IEEE P802.3cv D0p1 4-P	air PoE Maintenance 1	1st Task Force review comments
------------------------	-----------------------	--------------------------------

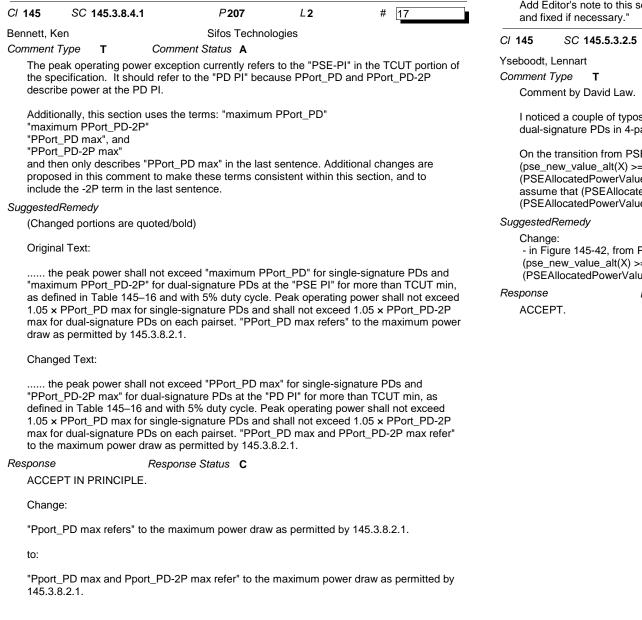
The spec requires to limit IClass and Imark to 100mA in case of overload/short circuit. In case of short circuit condition, depending on the dv/dt of the short, there MIGHT BE an overshoot above 100mA pending .It is not clear if current transient above 100mA for limited amplitude and duration is allowed since otherwise the classification circuit need much larger bandwidth for short-circuit condition during CLASS/MARK event. This transient is also depending on the dv/dt of the short condition.

I propose to unify all cases when we need to limit current with the allowannee of peak current >steady state current for 1ms maximum as we did for inrush.

The maximum peak transient current above Iclass_lim/Imark_lim shall not exceed 2000mA/TBD for 1msec max/TBD.Group to discuss TBD.

REJECT.

This comment was WITHDRAWN by the commenter.

I noticed a couple of typos in relation to Figure 145-42 'PSE power control state diagram for dual-signature PDs in 4-pair mode'

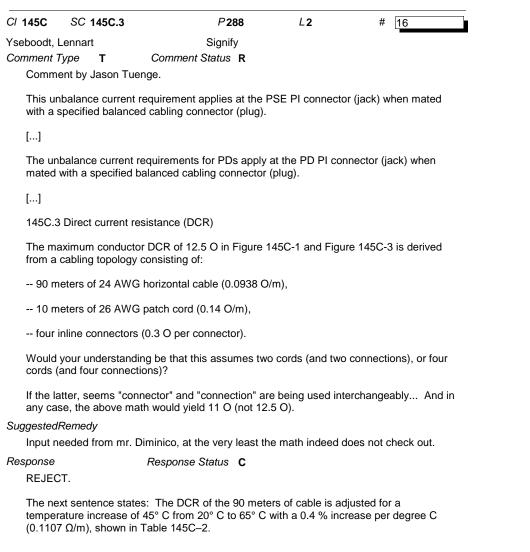
On the transition from PSE POWER REVIEW to RUNNING the equation is (pse_new_value_alt(X) >= PSEAllocatedPowerValue_alt(X)) * (PSEAllocatedPowerValue alt() [?] MirroredPSEAllocatedPowerValueEcho alt(X)). I assume that (PSEAllocatedPowerValue alt() is a typo and should be (PSEAllocatedPowerValue_alt(X).

- in Figure 145-42, from PSE_POWER_REVIEW to RUNNING, change to: (pse_new_value_alt(X) >= PSEAllocatedPowerValue alt(X)) * (PSEAllocatedPowerValue alt(X)) = MirroredPSEAllocatedPowerValueEcho alt(X))
